Office Action Summary	Application No. 10/626,463	Applicant(s) BARRY ET AL.	
	Examiner Joseph A. Dillon, Jr.	Art Unit 3651

DETAILED ACTION

Replacement Sheet
Title: Conveyor Track Drive
Inventor: Barry et al.
Serial No.: 10/626,463

FIG. 3

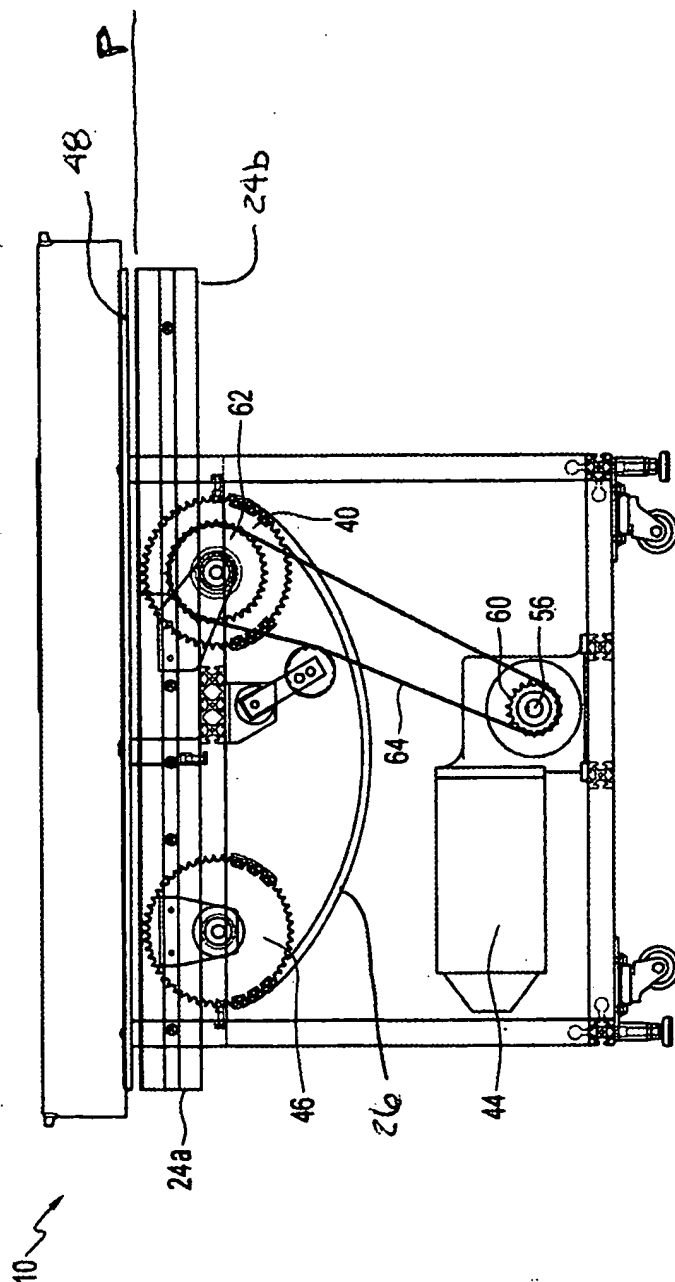
3. The proposed drawing corrections of 11/28/05 & 4/10/06 have not been entered as containing new matter.

The examiner acknowledges no new matter statements made by the applicant. However, the proposed drawing corrections show what the examiner sees as new matter.

In the original disclosure, element 48 had not been indicated in the original drawings. Additionally, element 52 was incorrectly indicating a feature. Further, element 50 was not originally depicted in such a way as to make clear it was actually in the plane P. For at least these reasons the original disclosure didn't clearly indicate that

the housing upper end, the guide, element 48 and the plane P were all coplanar and substantially the same feature.

Also, that the side walls of the track were not originally indicated as being coplanar.

Do
Not
Enter
Ex. 1.16

FIG. 4

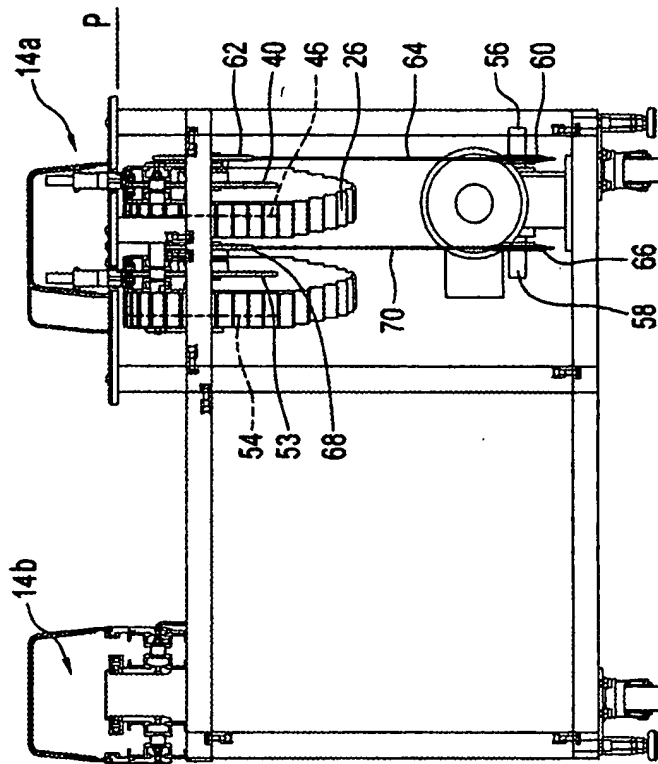
In Figure(s) 4, it was not originally clear that what is now indicated as element 20 were the carriers.

Do
Not
Enter
Ex. Dr. Gen
